Submission made on behalf of the Elford Group with regard to the Aerotropolis Core Draft Precinct Plan.

Submission: Western Sydney Aerotropolis Precinct Plan

This submission has been prepared on behalf of the Elford Group with respect to the property at 320 Badgerys Creek Road, Badgerys Creek (**the site**), and in relation to the implication of the Draft Aerotropolis Precinct Plan for the Aerotropolis Core (**draft Precinct Plan**) and associated technical studies.

Figure 5 Draft Precinct Plan Combined Land Use Plan extract

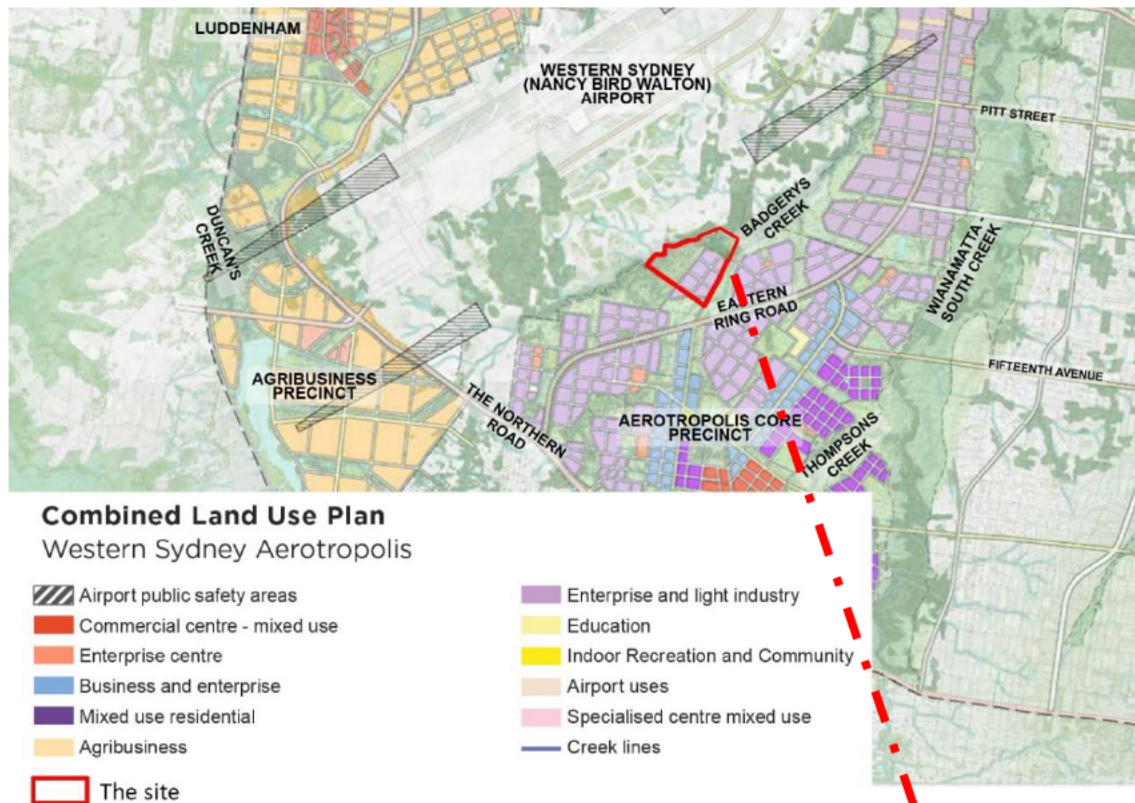
However, in the draft Precinct Plan 'Combined Land Use Plan' only the south-eastern portion of the site is identified 'Enterprise and light industry'. The north-western portion of the site is identified as 'riparian/linear parklands' (see **Figure 5**). This limits the development potential of the site to less than half of the land actually zoned ENT Enterprise.

The confusion created by the inconsistency between the Aerotropolis SEPP zoning map and the Draft Precinct Plan maps is exacerbated by the lack of detail and resolution provided within the Draft Precinct Plan maps. GIS maps for the Draft Precinct Plans have not been publicly exhibited for all Initial Precincts. This makes it challenging to determine exact property boundaries, and to delineate between parts of the site identified as 'enterprise and light industry' and those parts identified as 'open space' or 'parkland' etc.

Furthermore, the implications of the different designations between 'open space' areas and 'enterprise and light industry' areas shown in the Land Use Plan is unclear. It is expected that the zoning map in the SEPP which applies and ENT Enterprise zoning across the vast majority of the site would override the Precinct Plan 'open space' area designation – however this appears to be contradicted by clause 41 of the Aerotropolis SEPP.

This is even more problematic as the basis for determining what would appear to be a relatively arbitrary delineation between developable land and open space is not clearly articulated and is based on broad precinct-level studies instead of detailed site-specific studies and 'ground truthing'. Given the significant implications the Draft Precinct Plan mapping and controls will have on the future delivery of development of the Aerotropolis Growth Area, an alternative approach needs to be taken in finalising the Precinct Plans which allows for the setting of broad development parameters with further detail provided in subsequent development controls plans as site-specified detail emerges.

We recommend the Precinct Plan be amended to:

- » Remove any reference to an 'open space' overlay across the site
- » Provide a more flexible approach to identification of appropriate building footprints across the site
- » Provide detailed GIS mapping to assist stakeholders in confirming the key controls proposed for sites.

Figure 7 Draft Layout and Structure plan extract

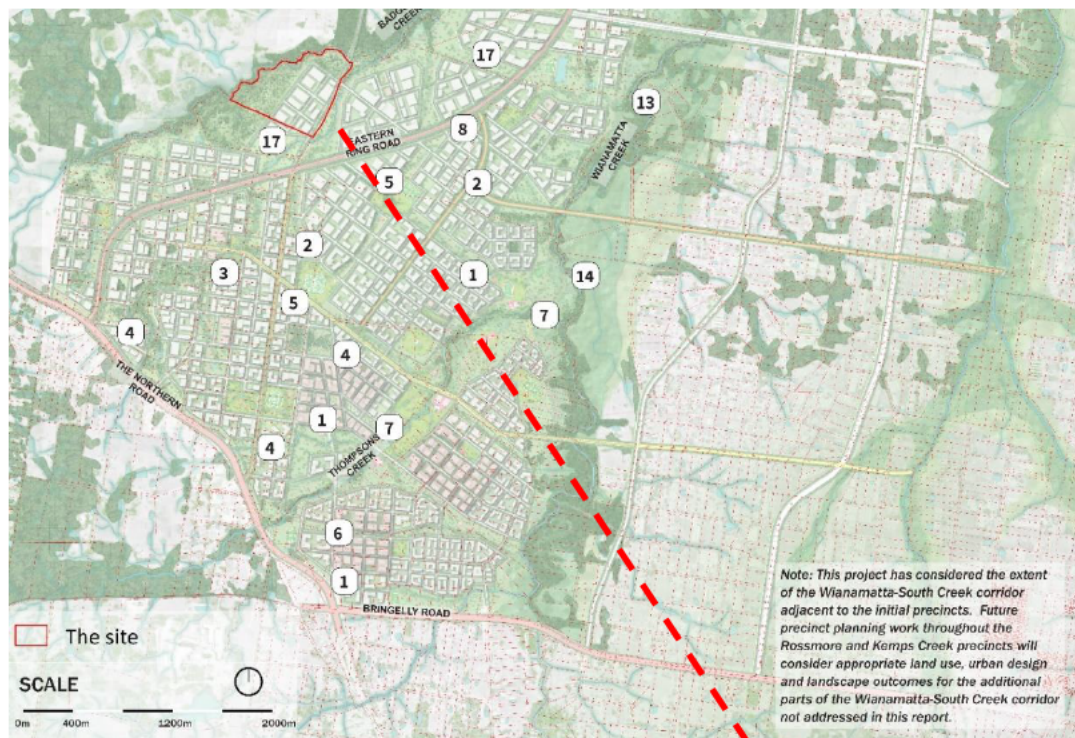
The Draft Layout and Structure Plan for the Aerotropolis Core Precinct identifies the site as '17. Existing quarries transition over time to employment land uses. Vegetation is retained where it aligns with flood and biodiversity objectives' (see **Figure 7** below).

Whilst no general objection is raised to the description of the site under the Structure Plan, the planning controls for the site do not reflect the intent for the site as articulated in the Structure Plan. Notably, existing vegetation is *only* to be retained where it aligns with flood and biodiversity objectives.

Whilst a 20 metre-wide riparian planting zone would typically be required to be provided either side of the Creek in accordance with the *Water Management Act 2000* (Water Management Act), the Draft Precinct Plan Open Space Network map applies an approximately 100 metre-wide 'riparian parkland' over the north-western part of the site effectively sterilising the development potential over this part of the site – far beyond that which would ordinarily be required under the Water Management Act. The basis for this is not clearly articulated or justified.

We recommend the Precinct Plan be amended to:

- » Remove any reference to an 'open space' overlay across the site
- » Provide a more flexible approach to identification of appropriate building footprints across the site

Figure 8 Precinct Plan height map extract

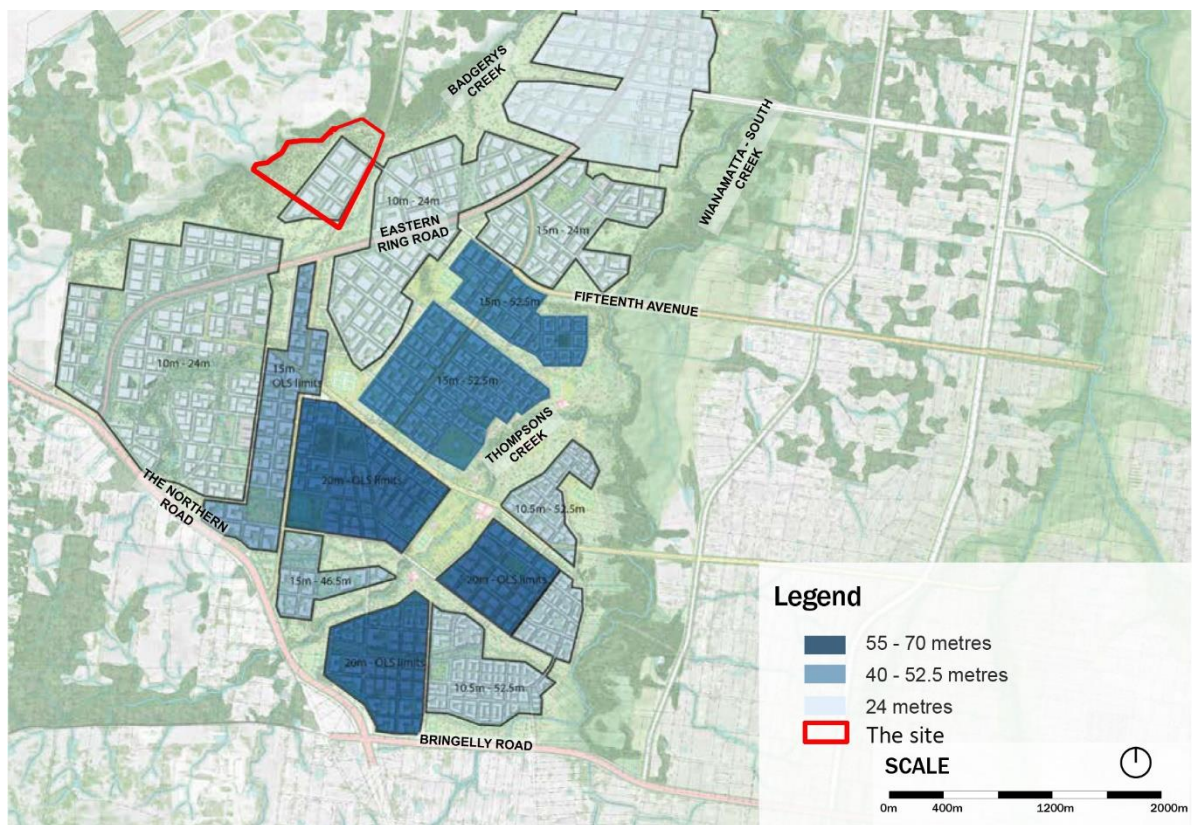
A height limit of 24 metres (see **Figure 8**) is applied to the proposed development footprint identified on the site which is less than half the maximum height that would be allowed under the OLS height control. The basis for applying such a low height control to a site zoned for what is ostensibly industrial and commercial purposes is not clearly explained and is inconsistent with many of the objectives for the Enterprise zone including the following:

Providing a greater height limit for the site will incorporate flexibility into the planning system to accommodate future technologies and employment-generating development which may not be envisaged at present. Given that the planning for the new airport will be so significant in Sydney's growth over the next few decades and its ability to respond to rapidly-changing technologies, it is essential that the planning system provide as much flexibility as possible. This is particularly the case for the height controls which would not result in any discernible impacts within such a wide extent of ENT Enterprise zoned land, but would support tangible benefits, if increased.

Increasing the maximum height to 59.5 metres (below the OLS) would have no discernible environmental or amenity impacts whilst allowing flexibility to deliver employment-generating uses consistent with the zone objectives.

We recommend a new height limit of 59.5m be applied to the site and higher development be permitted more broadly across relevant parts of the Precinct and in line with the OLS limitations (with some exceptions and lower building heights in locations where there could be an impact on proposed new population centres).

Figure 9 SEPP High Biodiversity Value map

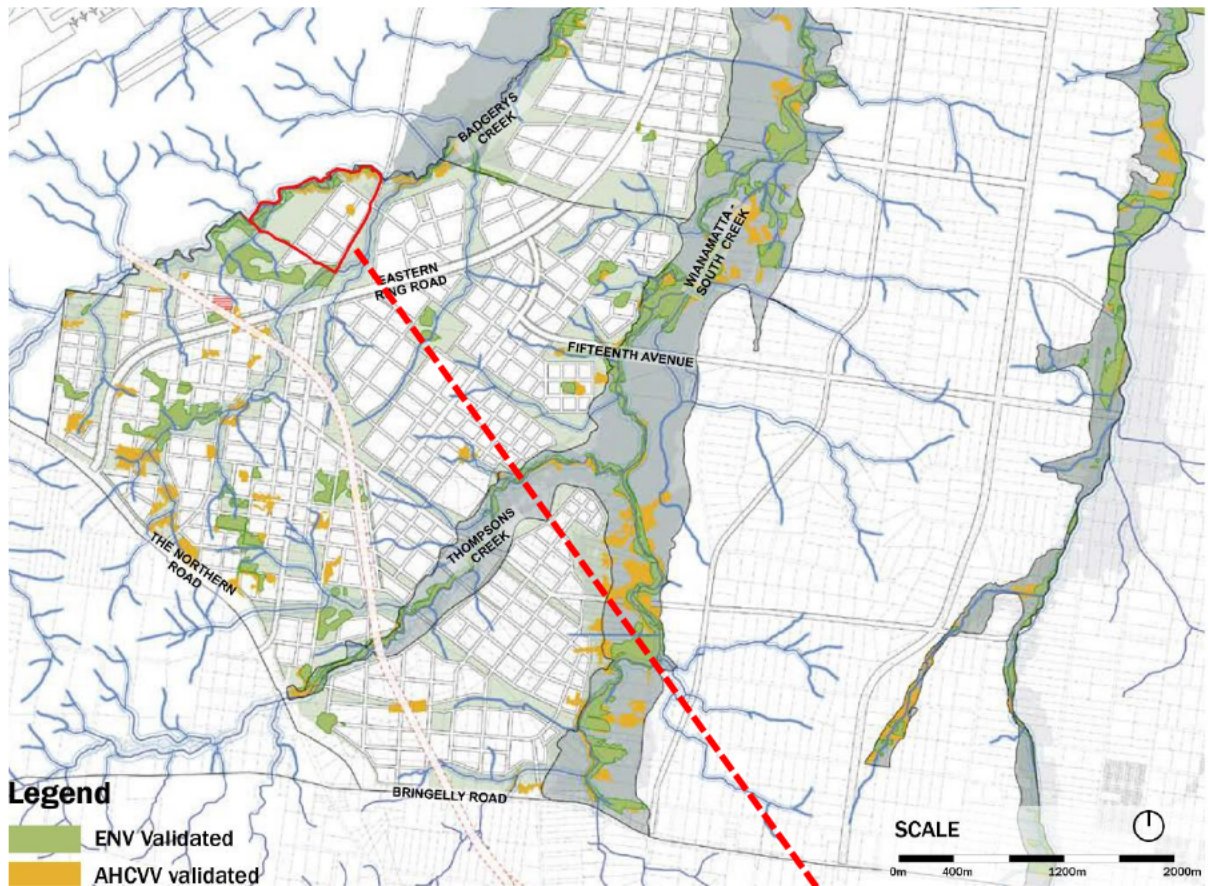
Notably, as shown in the extract of the SEPP High Biodiversity Value map at **Figure 9** below. The area identified by Cumberland Ecology as accommodating River-flat Eucalypt Forest community generally corresponds to validated environmental zoned land and Additional High Conservation Value Vegetation (AHCVV) land in the High Biodiversity Values map of the SEPP.

It is not considered appropriate for the Draft Precinct Plan and Aerotropolis SEPP to arbitrarily rezone land recently identified as ENT Enterprise to ENZ Environment and Recreation without any supporting evidence to demonstrate that there are ecological values present on the relevant sites. Applying an 'open space' overlay to areas required for the purposes of environmental purposes without any underlying biodiversity value is inconsistent with the objectives of the *Environmental Planning and Assessment Act 1979* (EP&A Act).

The only area of the site that might be considered in part suitable for retention and rehabilitation as a protected ecological community are some patches of the area identified as River Flat Eucalypt Forest. This generally aligns with the ENZ Environment and Recreation zone along the north-western portion of the site, freeing up the remainder of the site to deliver the forecast industrial, commercial and other supporting uses for the new airport, as well as the associated employment growth – in line with the lands zoning.

We recommend the Precinct Plan be amended to reflect the actual environmental attributes of the site.

Figure 10 Scenic and Cultural Connections

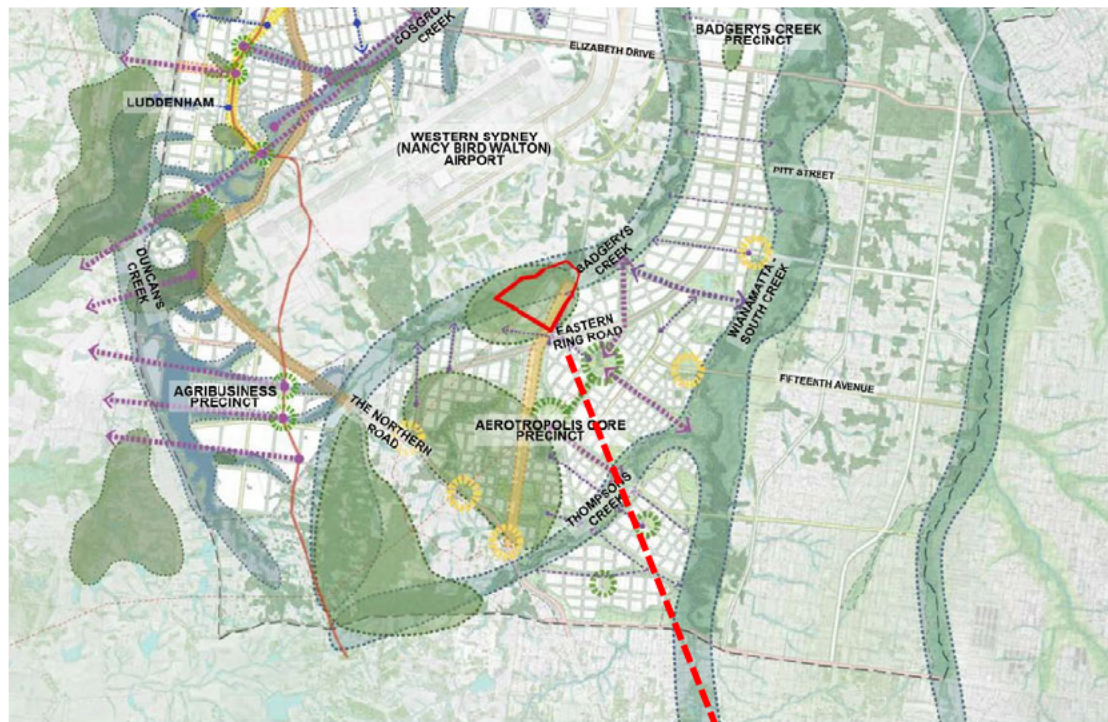
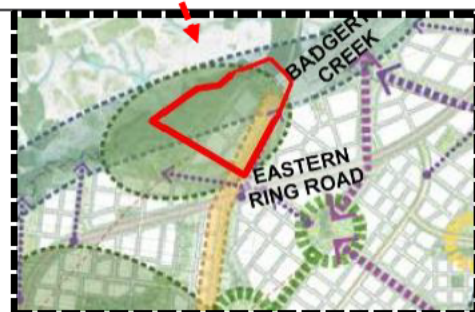
As shown in **Figure 10** below, the site is identified as accommodating “long views”.

The development potential of the site is proposed to be reduced in size and surrounded by parkland, that is constructed with no underlying environmental, scenic or cultural basis. This proposed parkland does not exist in the current environment, either physically or visually.

Furthermore, the identification of the constraints on the land seems to have arisen from incorrect mapping of this part of the site as having more natural vegetation than is actually present on the site. The Scenic and Cultural Connections map has several green lozenge-shaped areas with a green hatched boundary, that identify existing remnant vegetation, ‘framing long views’ (see **Figure 10**). An oval-shaped green area is located over the site. However, there are no technical studies from which this analytical plan is derived. Furthermore, there is no explanation as to what the long views are, how they are framed or from where they are experienced.

The vegetation that is in the potential view corridor would not be visible in the real world, as buildings in the foreground complying with the heights envisaged in the Draft Precinct Plan would block the view of vegetation situated on land between a viewer and the vegetation. A similar observation can be made about the potential views across the site from future development areas to the south and south-east.

We recommend the Precinct Plan be amended to reflect the actual attributes of the site and:

- » The oval designation of existing vegetation framing long views be removed from the site; and
- » The linear designation of the existing creek and associated vegetation framing long views be significantly modified to align with the creek only.

Figure 12 Archaeological heritage map (Extent 2020)

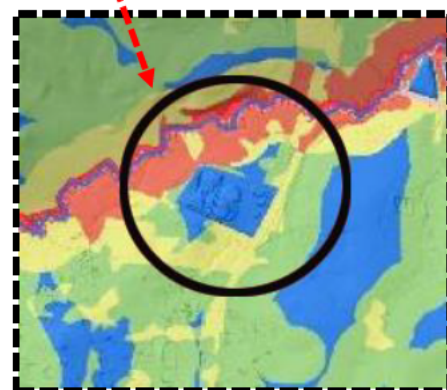
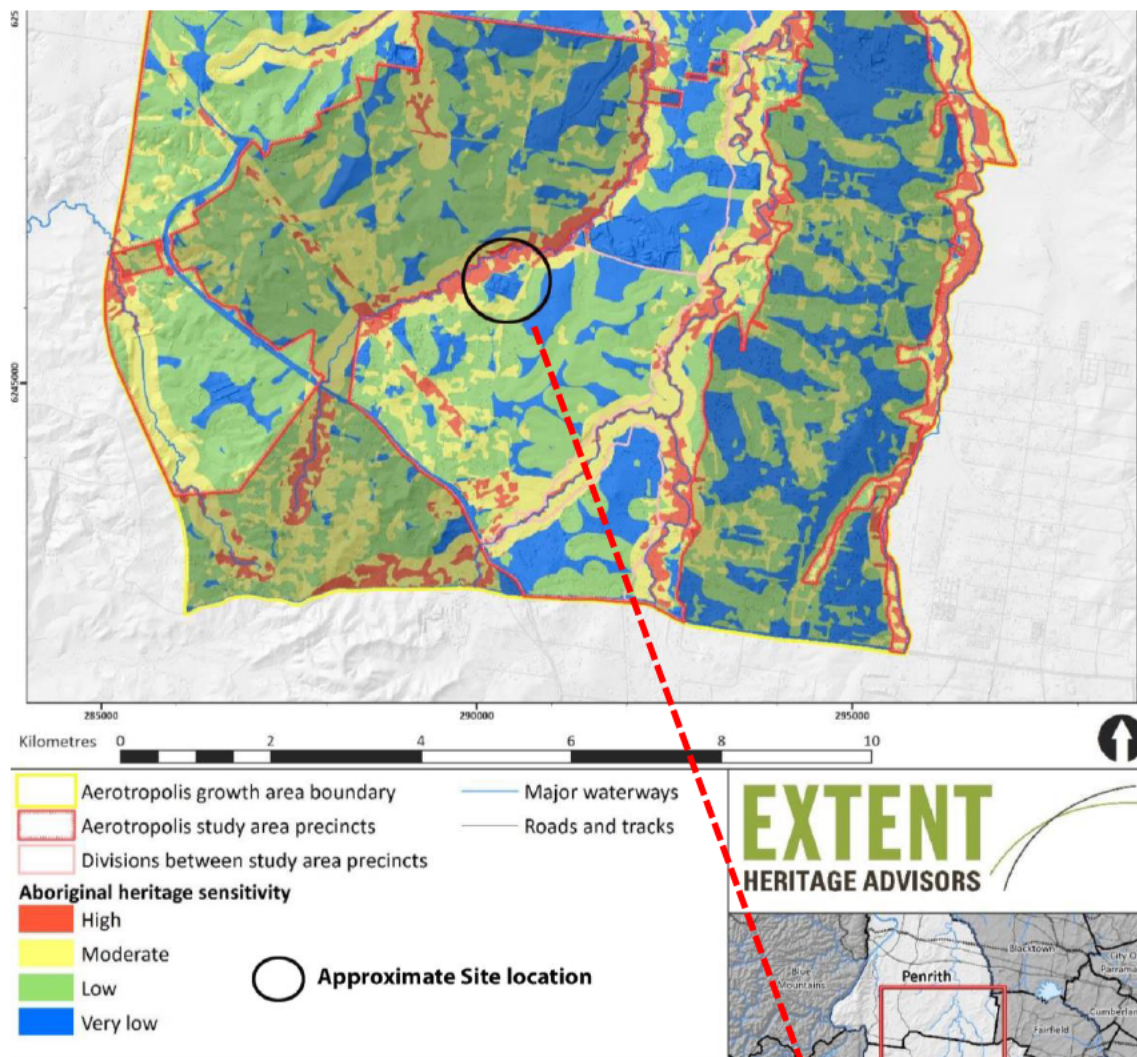
Furthermore, Extent does not appear to explain the process by which the Aboriginal archaeological sensitivity (refer to **Figure 12**) was determined. The high-level Aboriginal archaeological sensitivity mapping presented in **Figure 12** shows the subject property as having very low to high archaeological sensitivity, with moderate to high sensitivity along Badgerys Creek. This is counter to Extent's 2014 site specific assessment of Aboriginal archaeological potential, where the terrace/levee landform to the east of Badgerys Creek was assessed as being moderate (see **Figure 11** above).

A review of **Figures 12 and 13** indicates that the degree of the property that was assessed in 2020 to be sensitive is much greater than previously states by Extent in 2014. In light of Extent's recent investigation being limited to a desktop assessment, Kayandel suggests that the that the property specific assessment of archaeological potential by Extent in 2014 take precedence.

We recommend the Precinct Plan be amended to reflect the *actual* Cultural attributes of the site as assessed by Extent in 2014 and note that heritage conservation does not *prevent* development from occurring but rather requires an appropriate response to different constraints and opportunities on a particular site.
